BLUE BIRD

Defroster Fan Fuse Upgrade

BULLETIN

MODELS AFFECTED: 2011 MODEL YEAR BBCV "VISION" EQUIPPED WITH FEATURE 30026-06 OR 30026-07 6" AUXILIARY FAN WITH METAL GUARD.

Access Door

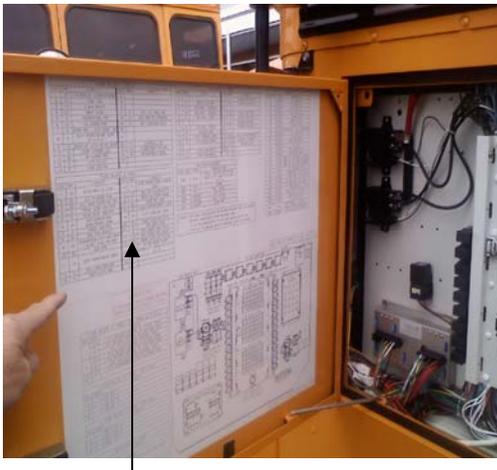
The capacity of the five amp fuses may be exceeded when heavy duty fans are started on high speed setting.

Replace up to three 5 amp fuses with 7.5 amp fuse for heavy duty fans. Update/Overlay all three decal positions to reflect change in fuse size, regardless of quantity of fans present on bus. Note that bus could have 1, 2 or 3 auxiliary fans, based on option package.

2. Unlatch and open exterior access door located below driver side window. (See above photo)

3. Replace applicable 5 amp fan fuses with 7.5 amp fuses part number 01696715 in fuse block FB3- cavity 3, 5, 7 as required (if present - see above photo)

4. Correct upper decal part number 10010169 located on inside of access door. Clean surface of old decal and place new overlay decals (provided) over existing decal on fuse block FB3- cavity 3, 5, 7 (amp column - see above photos) Verify all auxiliary fans operate in both low and high speed.
5. Place bus back in service.
